August 8, 2012

**Re: Proponent is attempting to rewrite the Public Consultation history
of the
Proposed Hydro-electric Generating Station at the Bala Falls**

Mitchell Shnier, on behalf of SaveTheBalaFalls.com

Figure 5 – Option 1, as shown as Layout Alternative 1 in Appendix A of October 2009 Environmental Screening Report (cropped, and property boundary and text added)

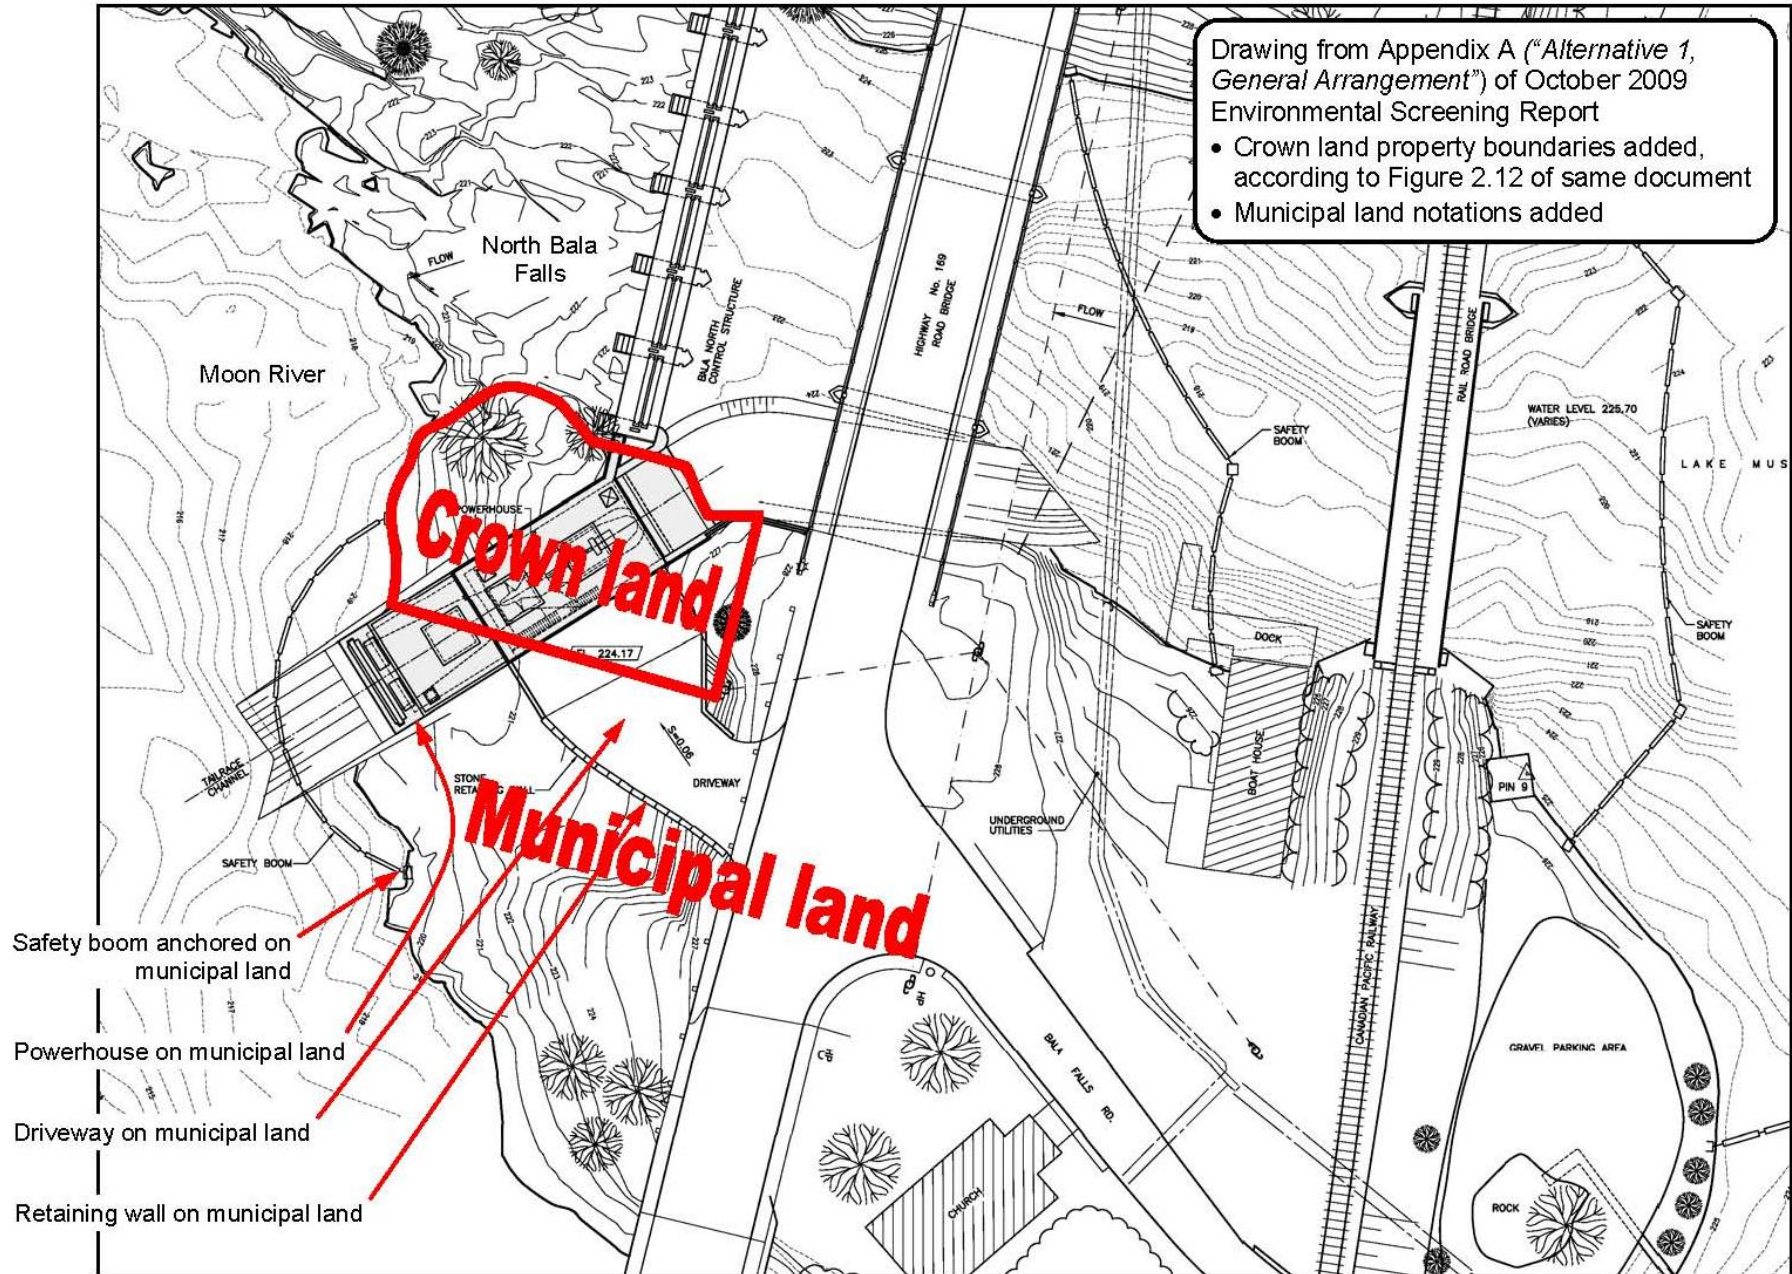
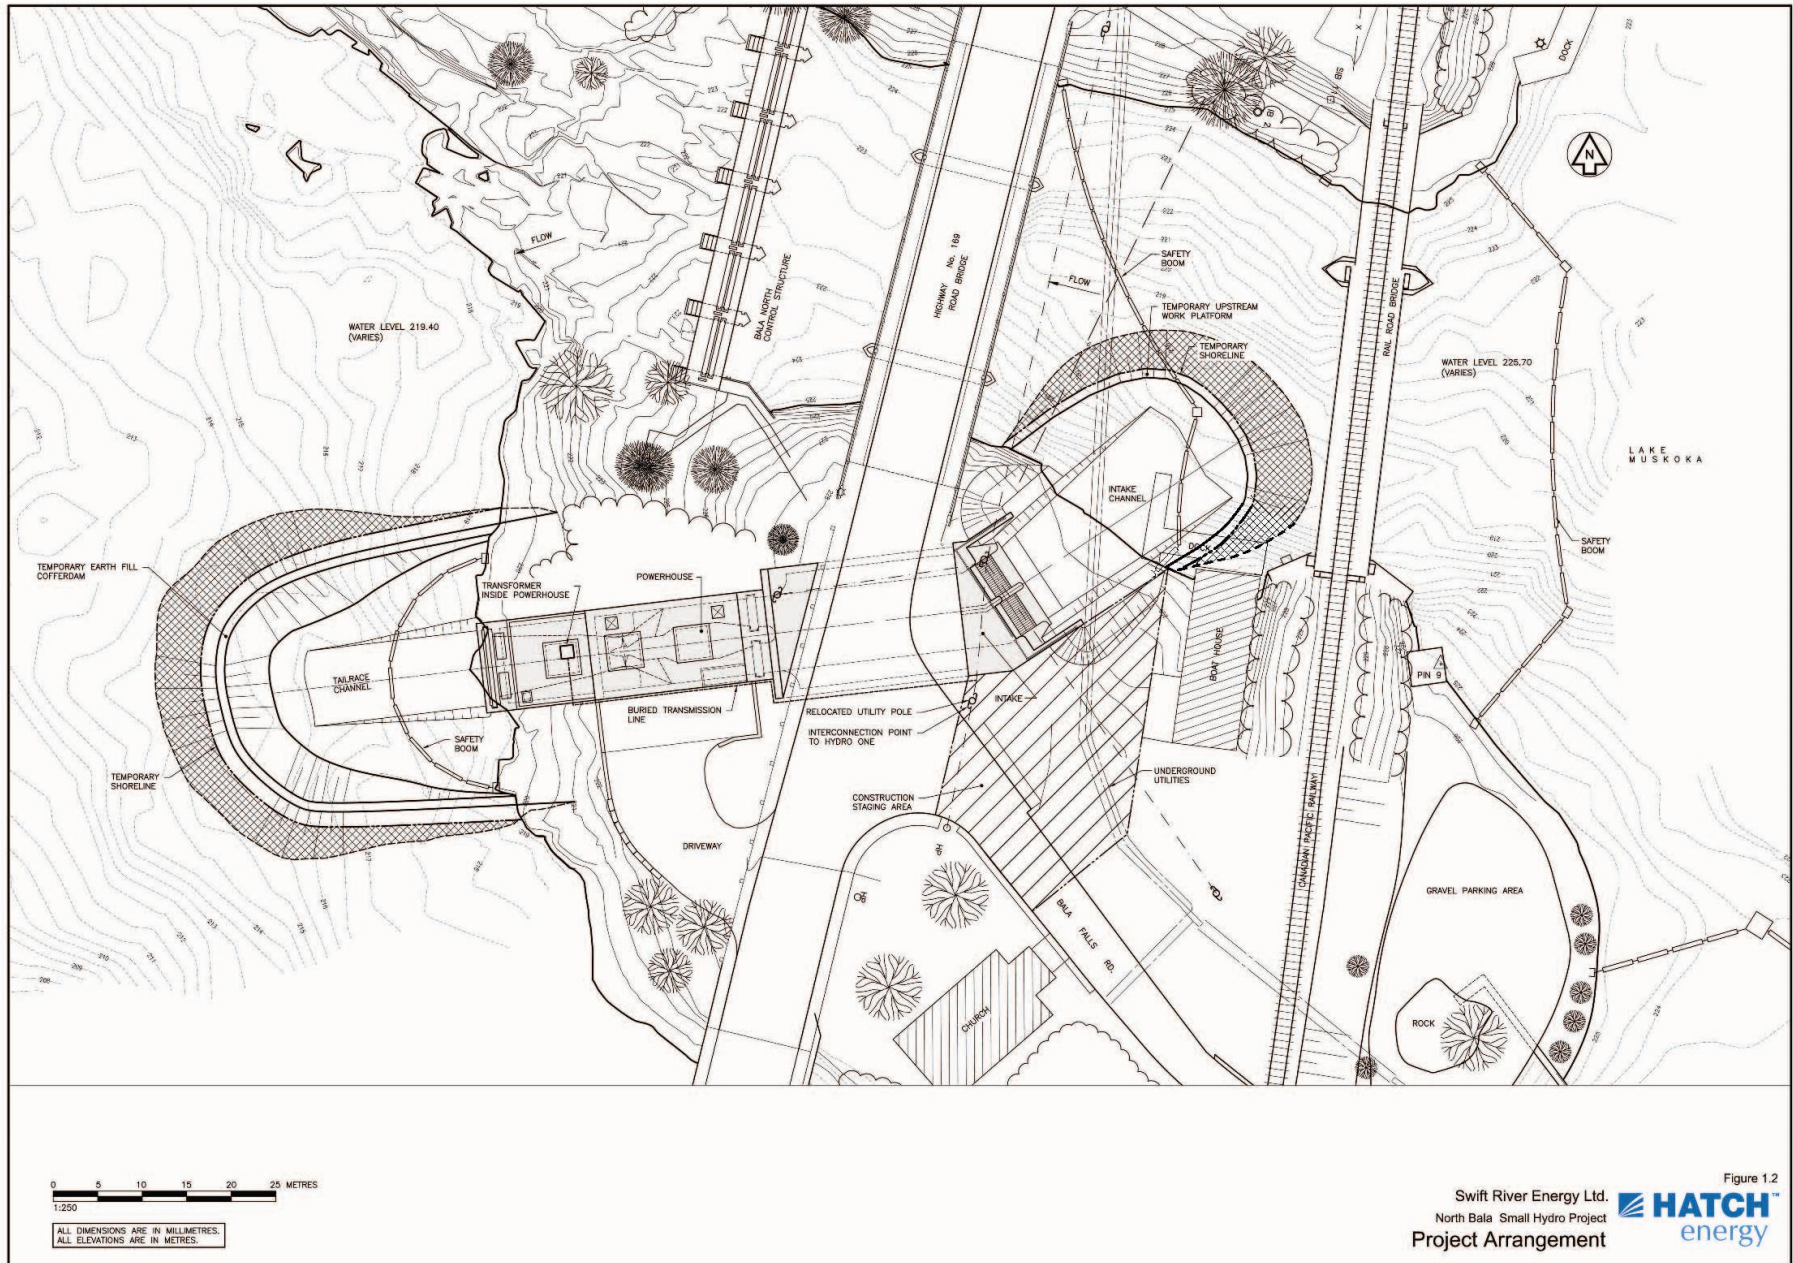
- c) Section 1.5.1.1, entitled *Layout Alternative 1*, of the proponent's environmental screening report, dated October 2009, states "*This original design (Drawing 327078-SK-101 in Appendix A2) was proposed as part of the as part of the site release program application ...*". This Section 1.5.1.1 also notes that "*Alternative 1 was presented during the Public Information Centre (PIC) of 2007*". This drawing is reproduced as Figure 4 below as provided in the environmental screening report, and as Figure 5 cropped and with property boundary lines and text added.

Figure 7 – Option 1, as posted on proponent’s web approximately September 2010, entitled “Option 1 General Arrangement”, removed from web site after a few weeks. Both posting and removal had no explanation of how this related to drawings provided previously or why it was removed

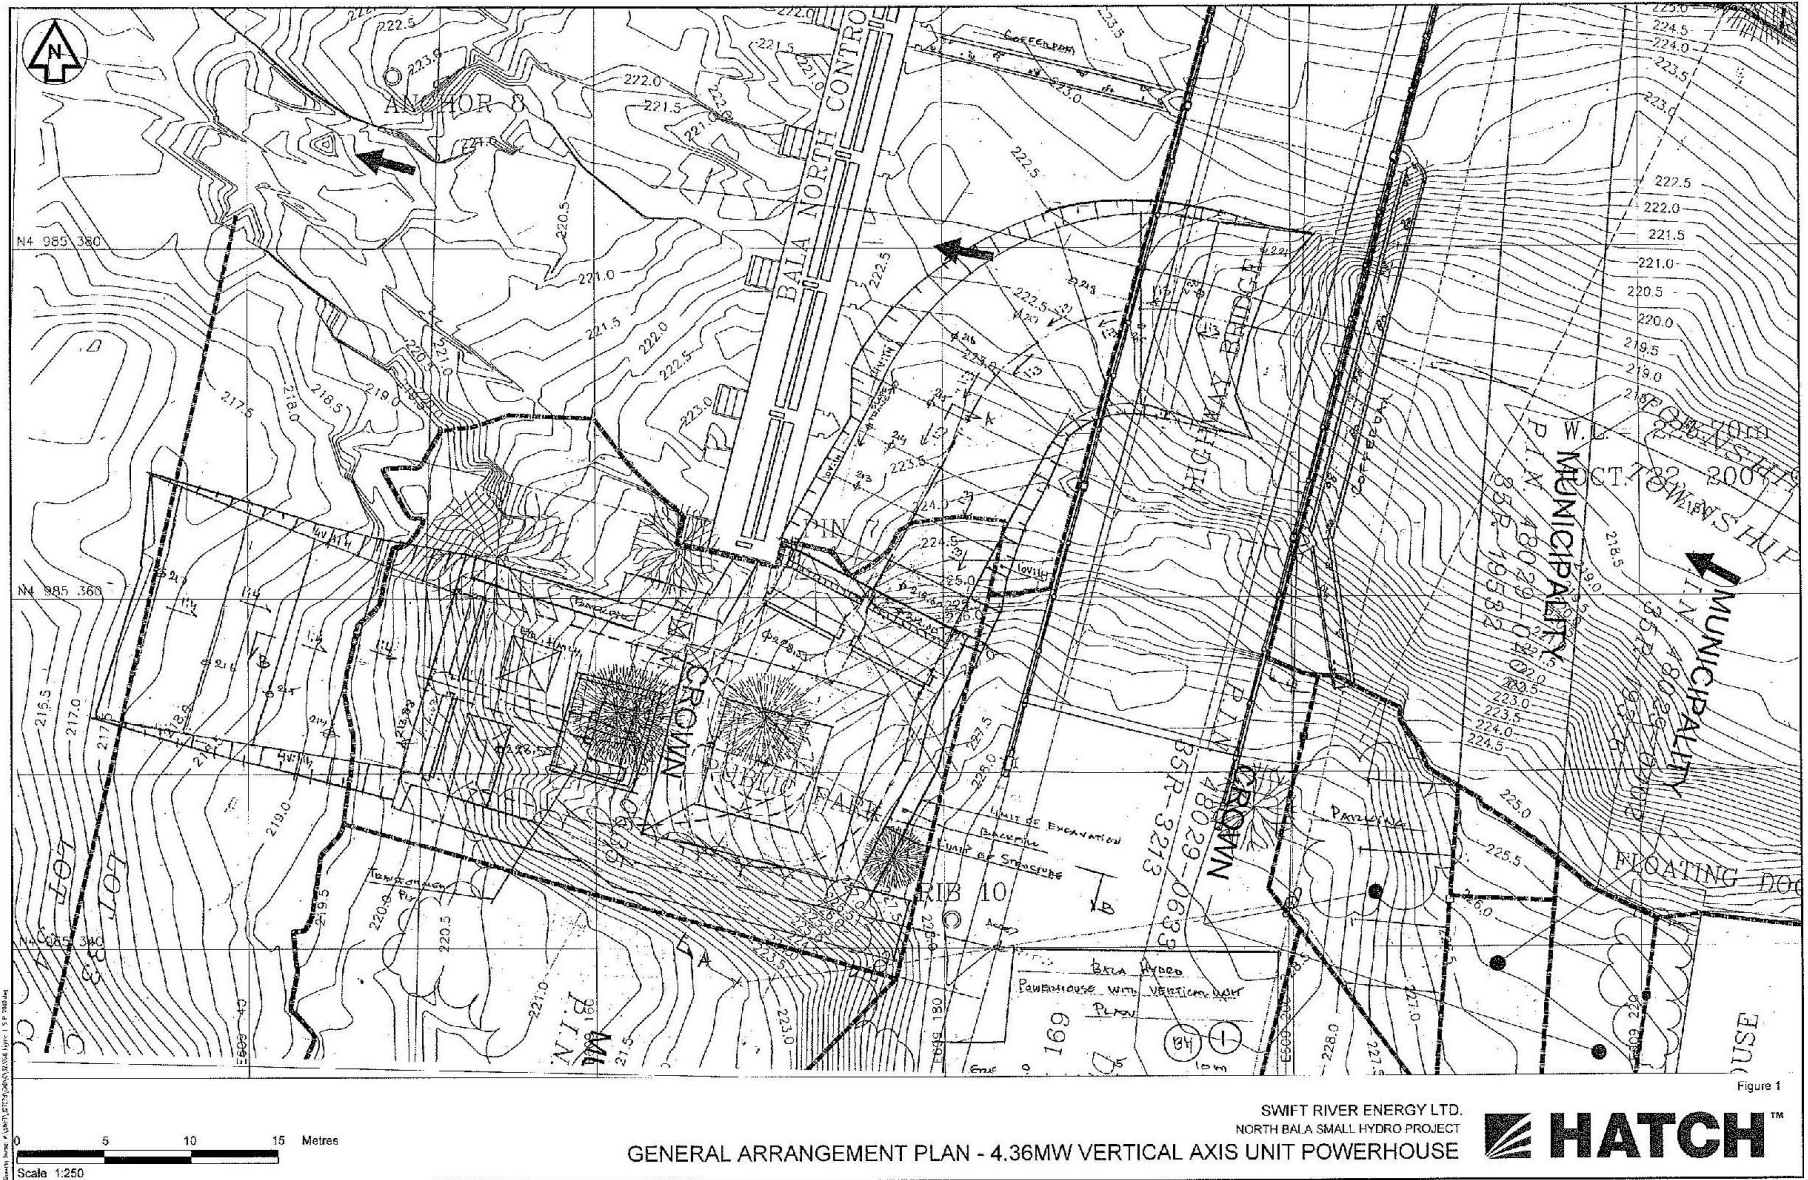
- 4) But subsequent to the October 2009 environmental screening report, in September 2010 the proponent posted on their web site yet another version of Option 1. This is reproduced as Figure 7 below, and was entitled "Option 1 General Arrangement".

- a) The proponent did not provide any explanation of why they posted this drawing or whether this was a new proposal, or if it replaced earlier drawings.

- b) Inexplicably, the September 2010 Option 1 drawing shows the proposed station's generating capacity would be even greater than their Option 2 proposal, even though Section 1.5.1.1 of their environmental screening report stated that Option 1 must have less generating capacity; *"...the location of the intake would be between the North Bala Dam and the highway bridge. This is not an optimum location from a hydraulic standpoint and head losses would be incurred."* So again, it would appear this was an inadequately-considered sketch rather than an actual possibility.

- c) This September 2010 drawing contradicts not only the Option 1 drawing in the environmental screening report (as it would apparently not require municipal land), but this also contradicts the October 14, 2008 drawing in that the tailrace is angled so the dangerously turbulent water exiting the tailrace would be angled towards the base of the north falls and towards the private docks on the north shore of the Moon River.

- d) But without explanation, this new version of Option 1 was removed from the proponent's web site after a few weeks.
- 5) The proponent has never provided any explanation of these many versions of Option 1, we don't know what was possible and why drawings were retracted.

Figure 8 – New Proposal / “Alternative 1A”, as presented as Figure 2.1 in May 2012 Addendum

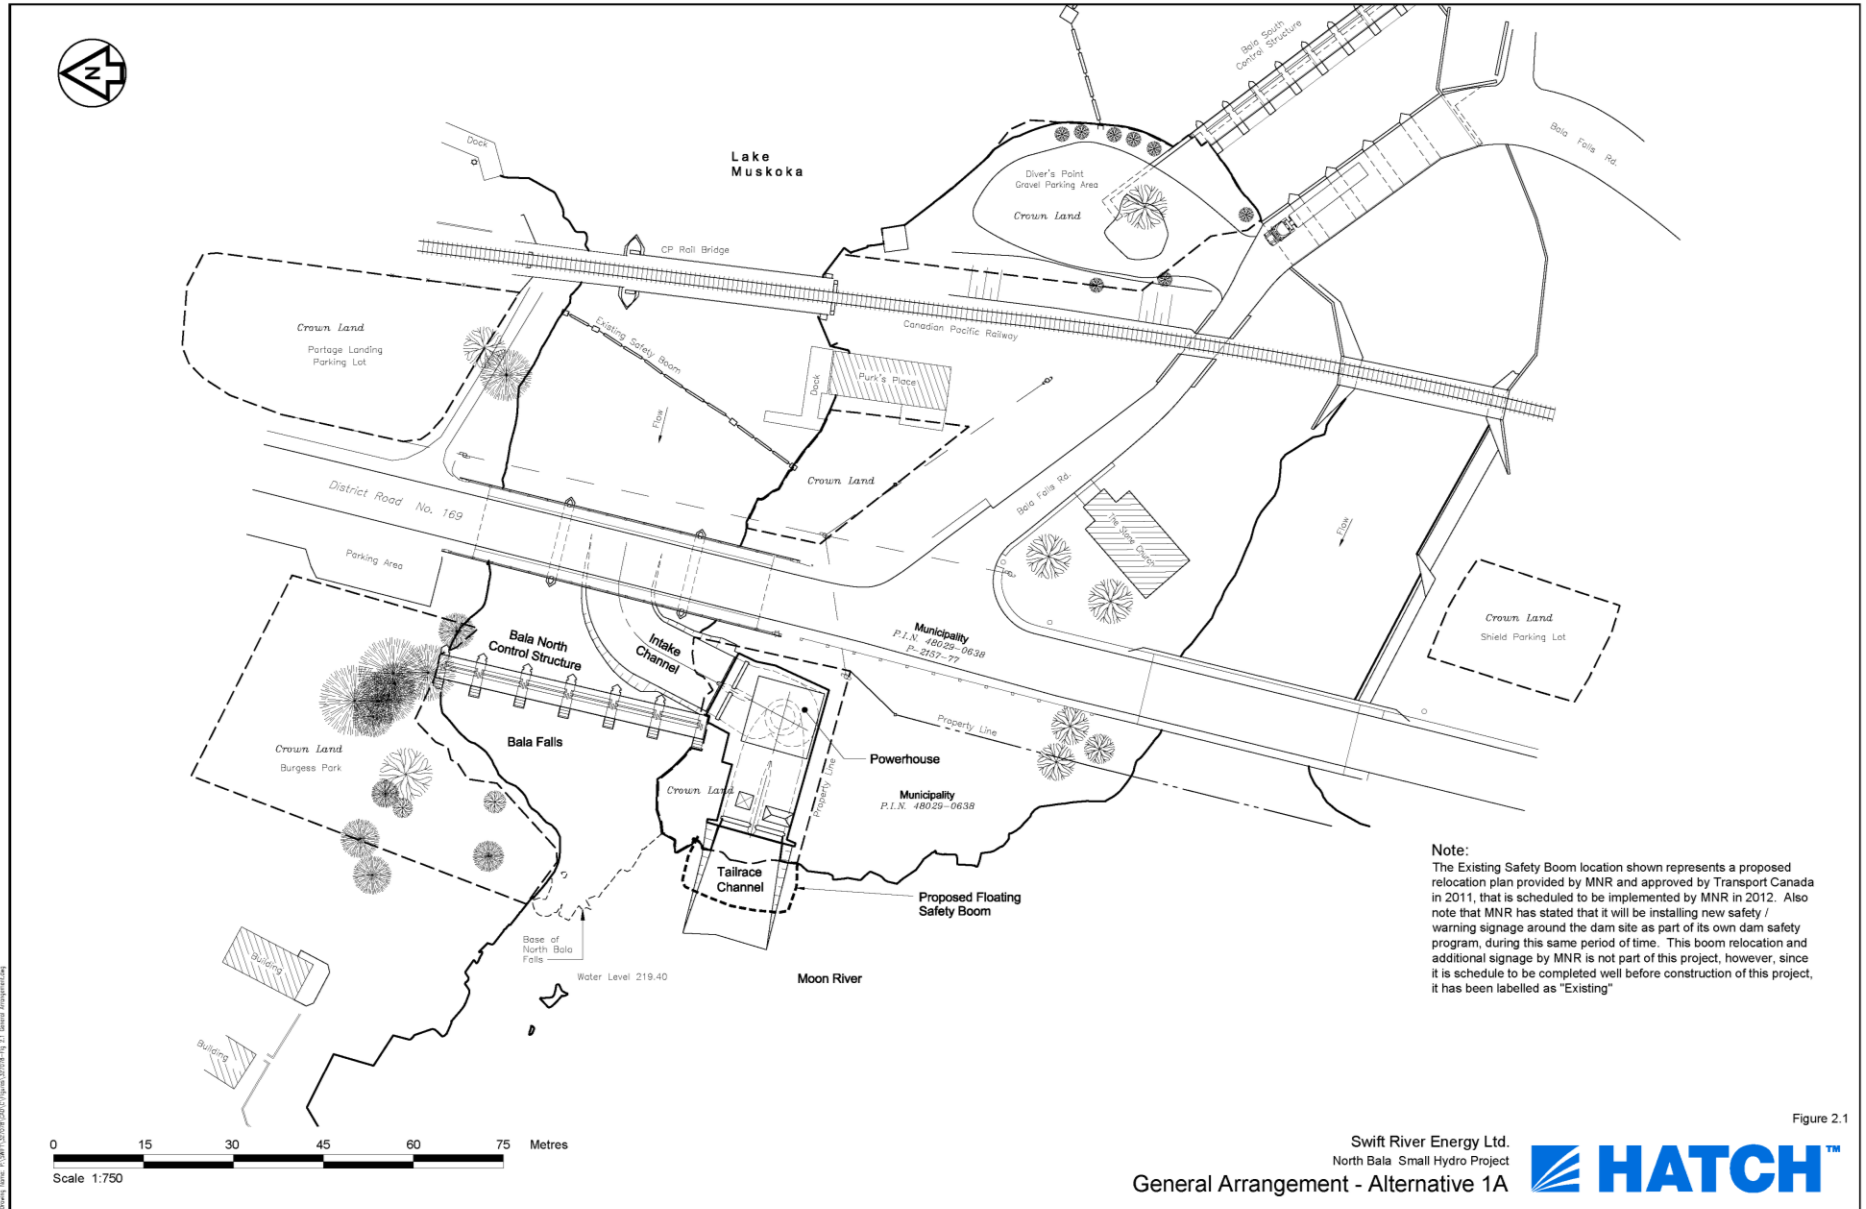
- a) On May 30, 2012 the proponent released an Addendum in which they presented a Figure 2.1 and described this as "Alternative 1A", this is reproduced in Figure 8 below.
- b) As is clear by comparing the location and orientation shown, this is the first time the public has been presented with a proposal which:
- Is described as being a possible proposal and shown to only require Crown land.
 - Has the water flow exiting the tailrace angled towards the base of the north falls and towards the north shore of the Moon River.
